MAIN 17, FOUR MILE CREEK
CRESTVIEW SEWER - PHASE 1

SANITARY SEWER LINE NO. 1

JAMES L. ARMOUR, P.E. - ACTING CITY ENGINEER
CITY OF WICHITA PROJECT NO. 466-83983

SANITARY SEWER LINE NO. 1

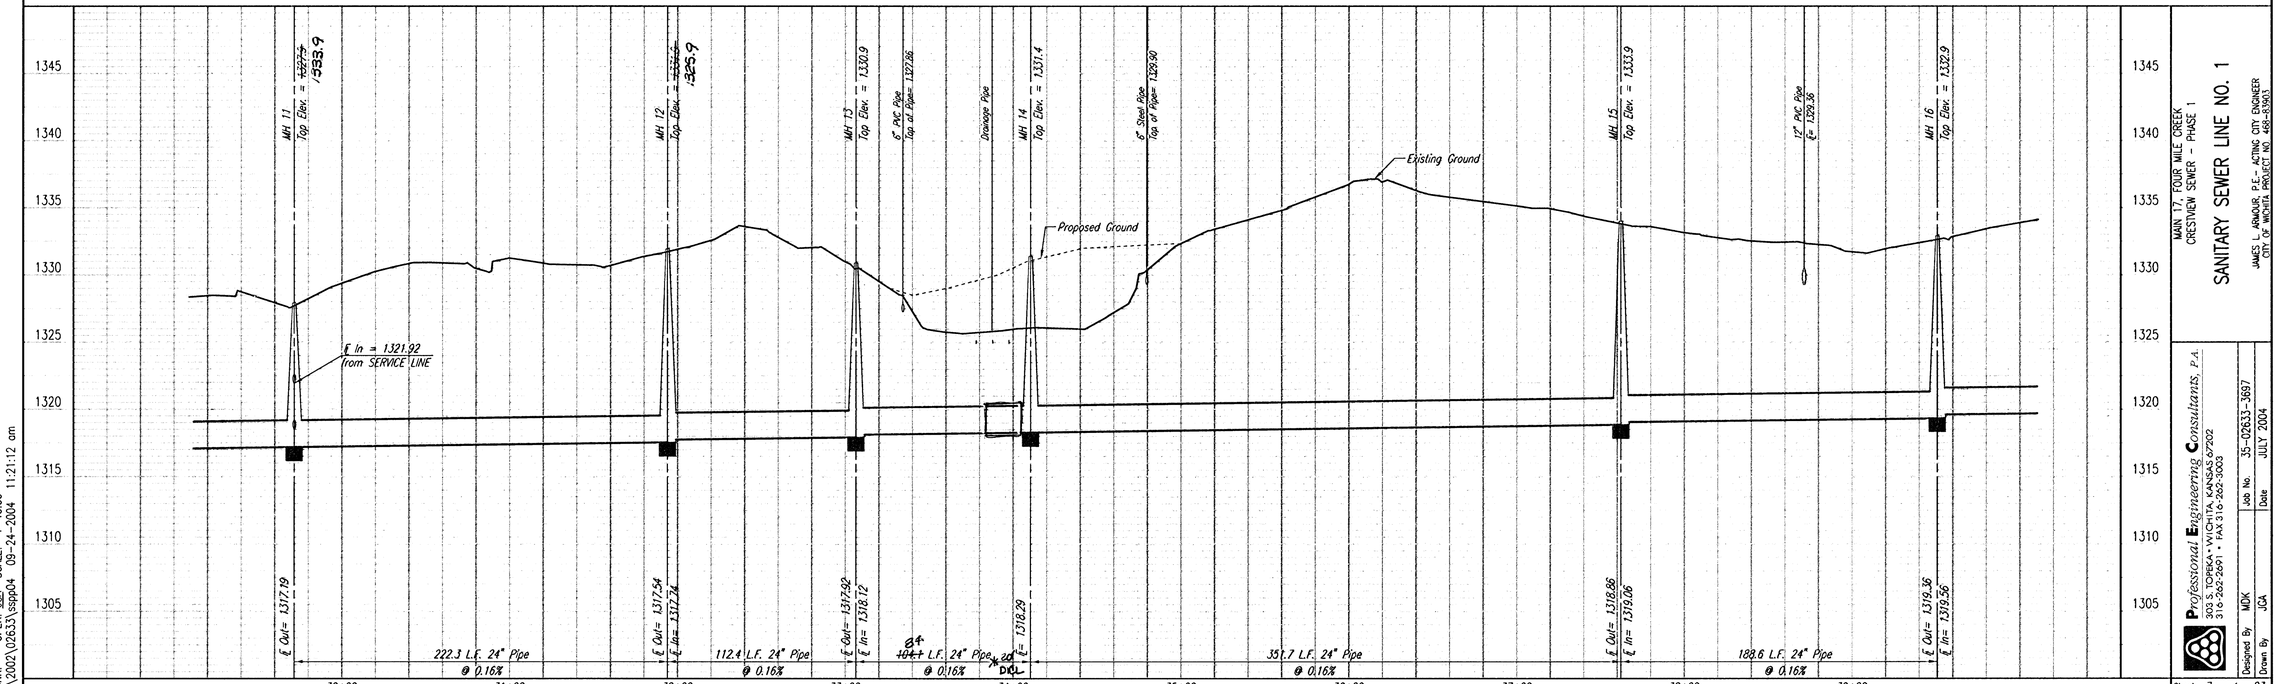
Install ~~104.1~~ 84.1 L.F. 24" Pipe

Note #2: Doghouse MH @ Sta. 33+98 needed for 24" RCP intake pipe- irrigation system. 20' DICL 24" SS thru MH. Intake pipe top section removed - 8' into bottom of SS.

Install 20 L.F. 24" DICL Pipe see note #2
